## **Amendment C384 to the Melbourne Planning Scheme**

### **Expert Witness Statement of Robert Campbell Swan - Flooding**

**5 October 2022**

Figure 7-1 – Comparison of GHD model tide condition with real 2009 tide

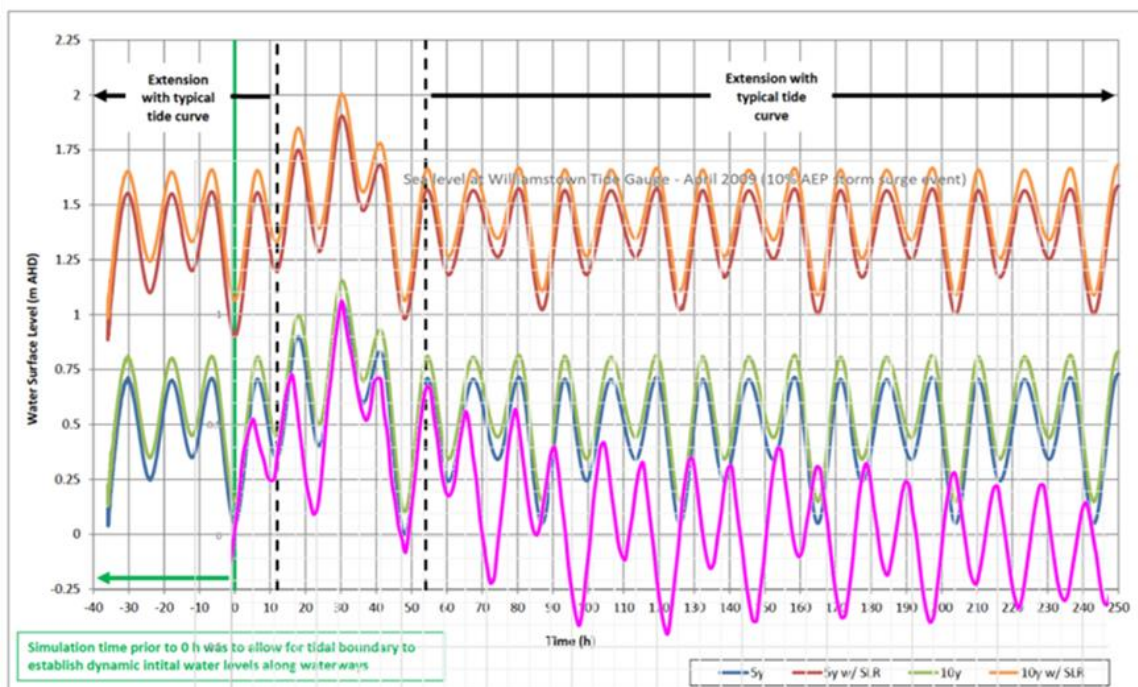
To demonstrate the issue, Figure 7-1 below shows the recorded 2009 tidal surge event in magenta (approximately equivalent to a 20% AEP event) plotted against the tidal series used by GHD (as per Appendix C of their report).

Based on the real tide data, there are some issues that become immediately apparent; firstly, the real tides revert back to a more normal tidal cycle relatively quickly after the conclusion of the surge event. The lower tide levels will enable greater flow capacity in the river, as the average tailwater level is lower over the entire tidal cycle. This decay characteristic is typical of all storm surges. The recorded 1934 tide levels show that 24 hours after the peak of the tide, the high tide level was approximately 0.5 metres, which is only slightly elevated above the normal high tide level. At 48 hours post the peak, the high tide level had returned to 0.3 mAHd, well within the normal tidal range.

The tidal cycle also does not show the normal Melbourne diurnal tidal characteristics, that has 4 distinct elements each cycle - Higher High Water, Lower High Water, Higher Low Water and Lower Low Water. As the GHD series has been copied from the edges of the storm surge series and repeated, these characteristics of the tide are lost.

Figure 7-2- Modelled water levels, Lower Yarra River

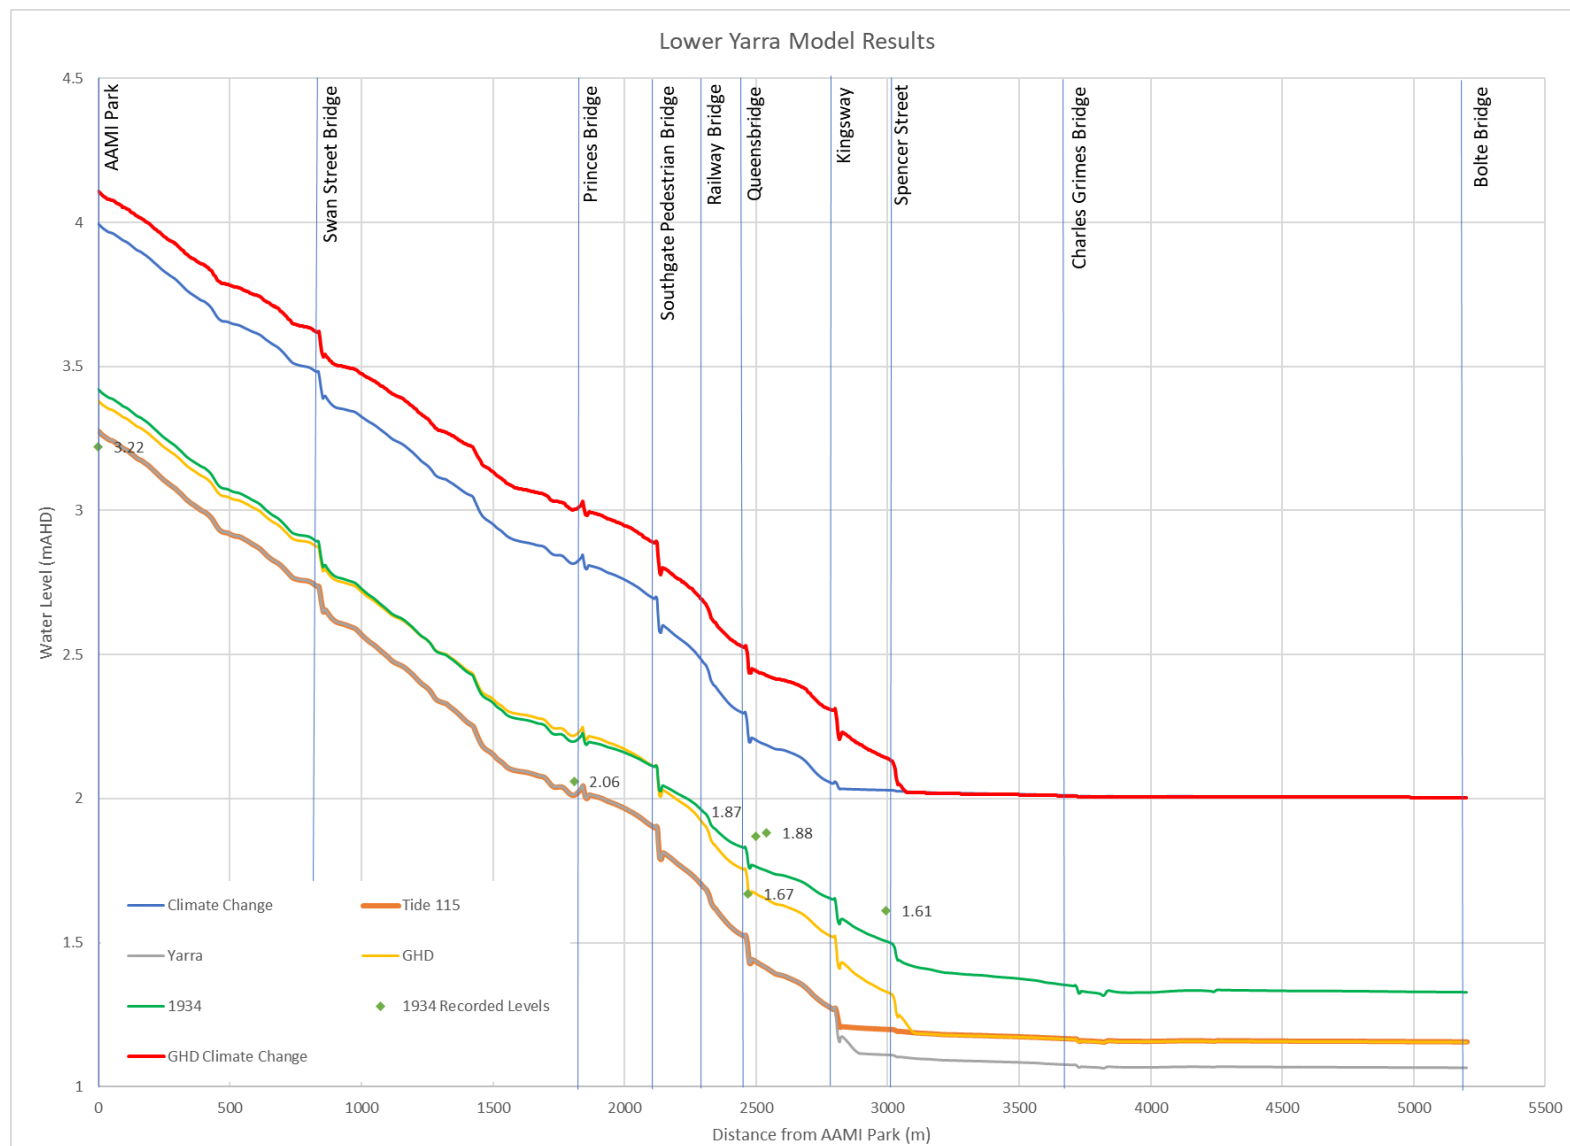
A long section comparing the flood levels along the Yarra for the HARC model is shown in Figure 7-2. The flood levels just upstream of Princes Bridge in each case are also shown in Figure 7-3.

The only change between the various model runs for the same inflow hydrograph (existing or climate change) is the tide boundary. The adoption of the GHD tides in the modelling contributes to an increase in flood levels of approximately 0.2m at Princes Bridge, when compared to the realistic tidal series. For the climate change case, this is seen in the difference between the blue and red lines in Figure 7-2 and Figure 7-3, where the red line is the result from the model using the GHD tide series and the blue line uses the corrected tidal boundary, adjusted for climate change. The effect of the incorrect tide in the model is increased levels along the entire lower Yarra reach modelled, from Spencer Street to AAMI Park. This in turn would lead to larger flood extents than predicted along the entire lower Yarra.

Inherently, the flood levels in and around Southgate are a function of the time that the modelled water level exceeds the top of the Yarra River embankment. This analysis indicates that the GHD levels are likely to be at least 200mm too high when considering a reasonable tidal cycle, notwithstanding any other errors in the model. This then significantly increases the time when water overtop the Yarra River embankments, leading more water spilling into the Southbank precinct and higher flood levels. When translated to a flood extent, the area covered by the extent is much larger under the incorrect tide.

Figure 7-3 – Modelled water levels, upstream of Princes Bridge

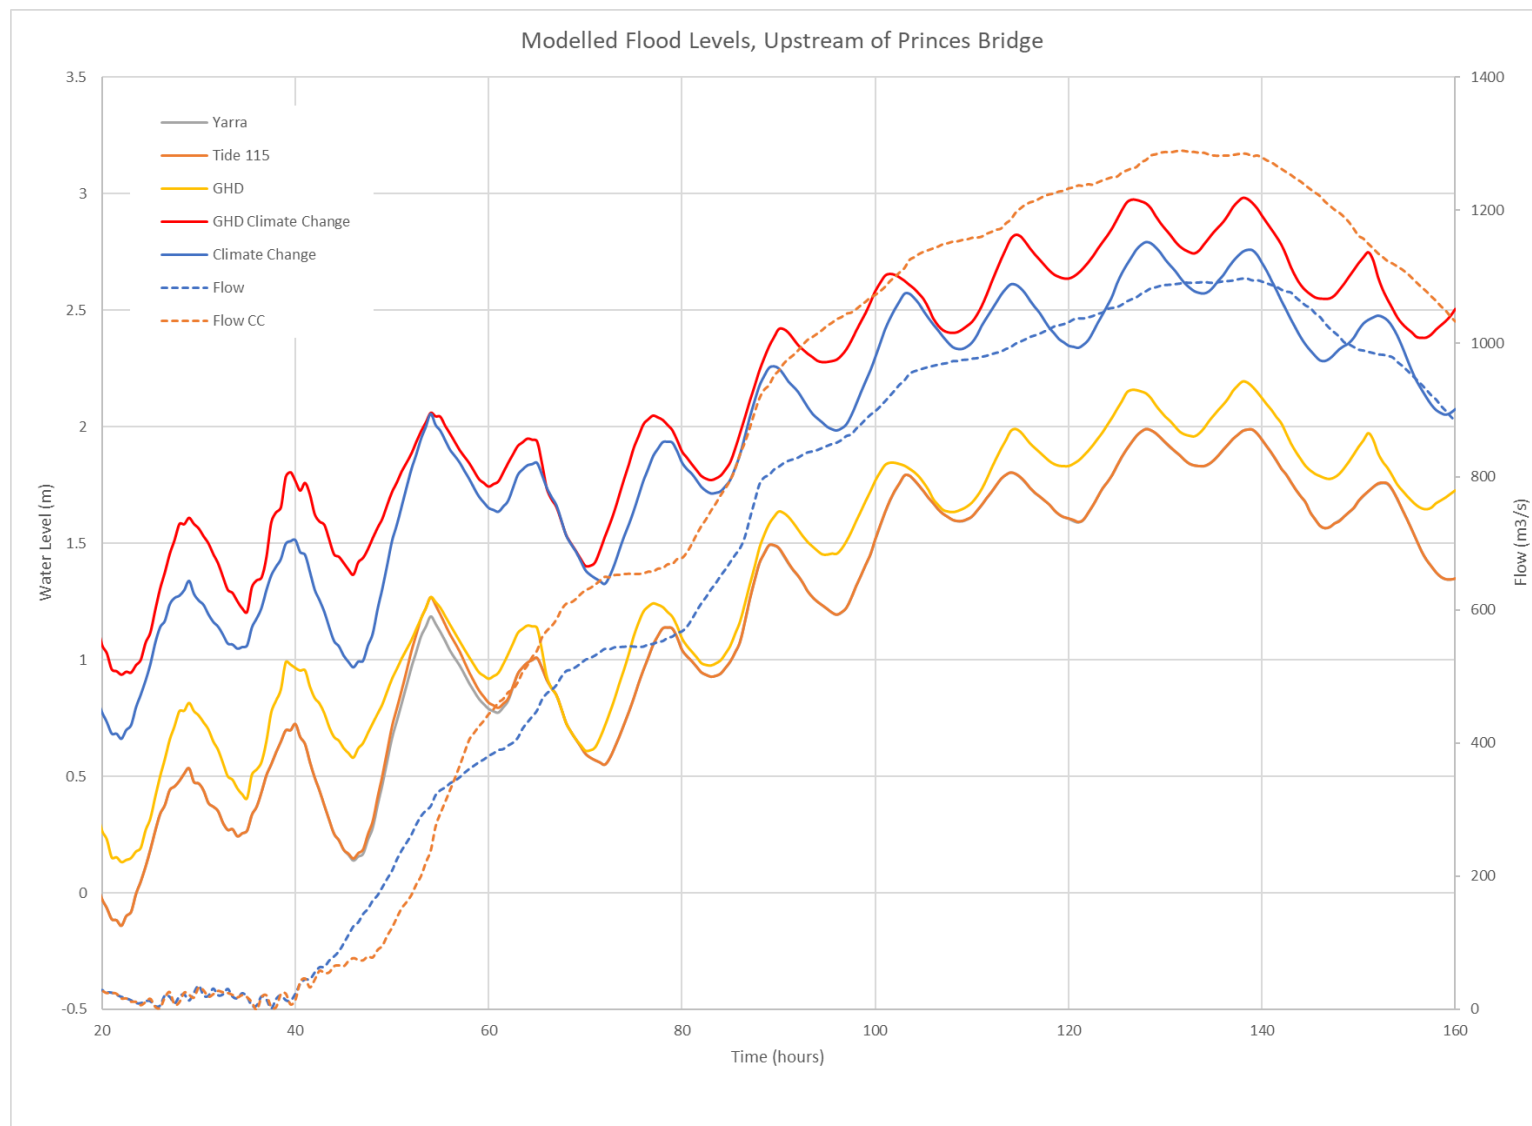
It should be noted that the results of the HARC model are lower than the equivalent GHD model under all conditions. The HARC model also slightly overestimates the 1934 results at Princes Bridge, but to a lesser degree than the GHD model. Figure 7-3 shows the modelled flood levels at Princes Bridge.

I note that in the modelling I have undertaken, I have not been able to replicate the high water levels indicated in the GHD results under any combination of input conditions. This is likely due to the differences in the assumed bottom bathymetry, the assumed losses at bridge and structures, and potentially the adopted inflows or Mannings values. However, the HARC model did adopt a reasonable estimate of the 1934 conditions and returned levels in the vicinity of Southgate that were a slight overestimate of levels upstream of Princes Bridge and a close approximation of the recorded level at Queens Bridge.
